PRODUCT CHANGE NOTIFICATION

Bourns® Model SRR1260A and SRR1280A Series Shielded Power Inductors

Manufacturing Site Relocation, Process Automation and Core Change

IC24129

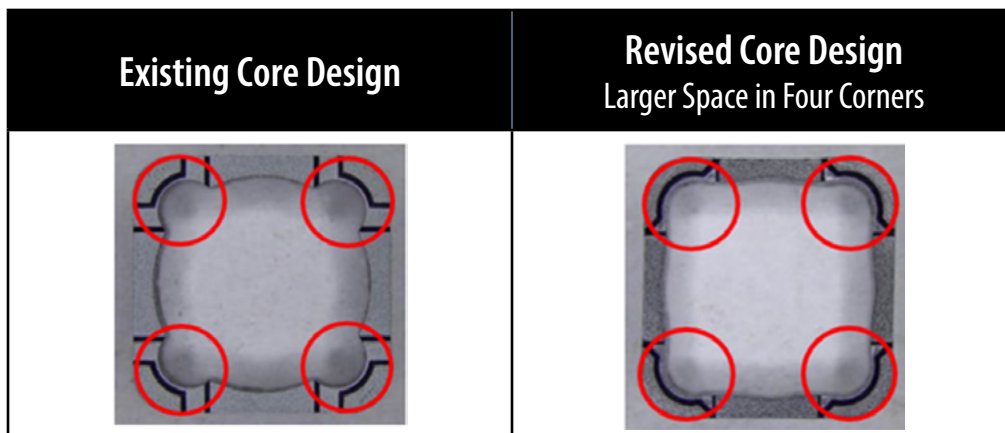
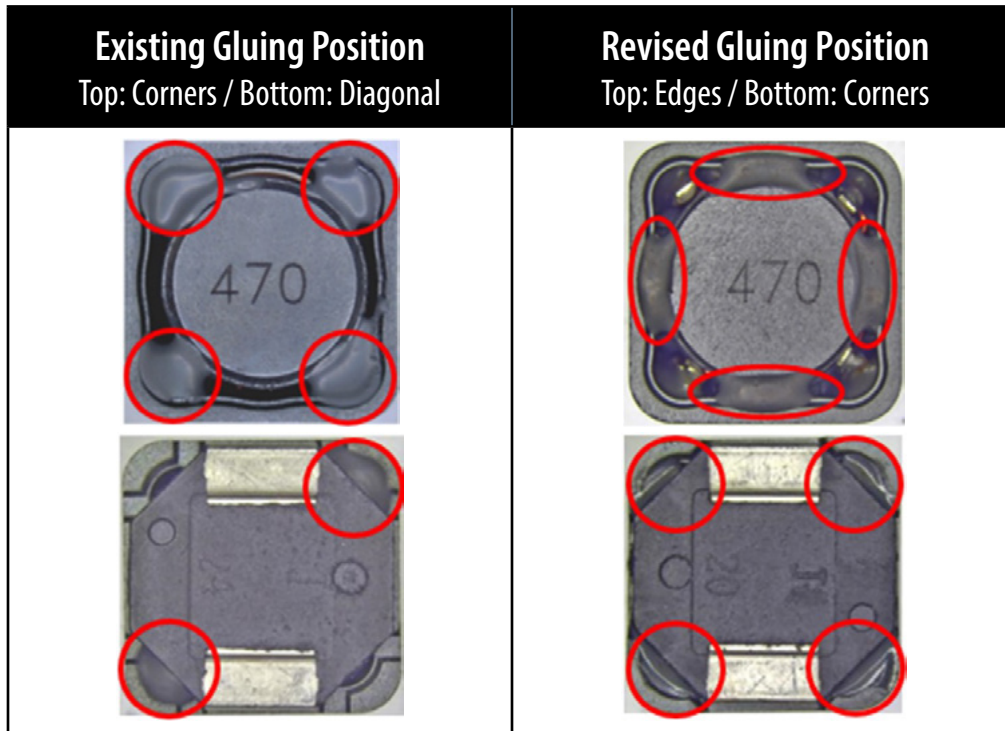
Additionally, the core design and supplier of the Model SRR1260A Series will be changed. The modified inductor core has larger spacing at the four corners.

As shown in the images above, the form of the affected part numbers will change slightly due to the change in core design. The fit and function of the affected part numbers will remain the same. The country of origin of the affected part numbers will remain the same. The quality and reliability of the affected inductors should be improved as a result of the changes. Traceability will be maintained through lot code and date code.
